Tyres: UN Regulation No. 117 (Tyre rolling resistance, rolling noise and wet grip)

Proposal for a Supplement to UN Regulation No. 117

Submitted by the experts from France*

Example 3

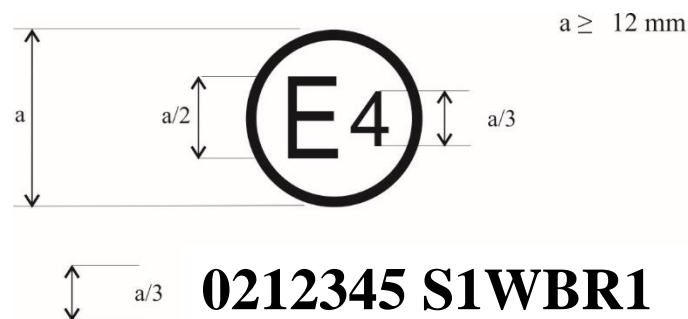
Annex 2, Appendix 1, insert a new example 3 to read:

The above approval mark shows that the tyre concerned has been approved in the Netherlands (E 4) pursuant to Regulation No. 117 (marked by S1 (rolling sound at stage 1) W (wet adhesion with tyre in new state) B (wet adhesion with tyre in worn state), and R1 (Rolling resistance at stage 1) under approval number 0212345. This indicates that the approval is for S1WBR1. The first two digits of the approval number (02) indicate that the approval was granted according to the requirements of the 02 series of amendments to this Regulation.
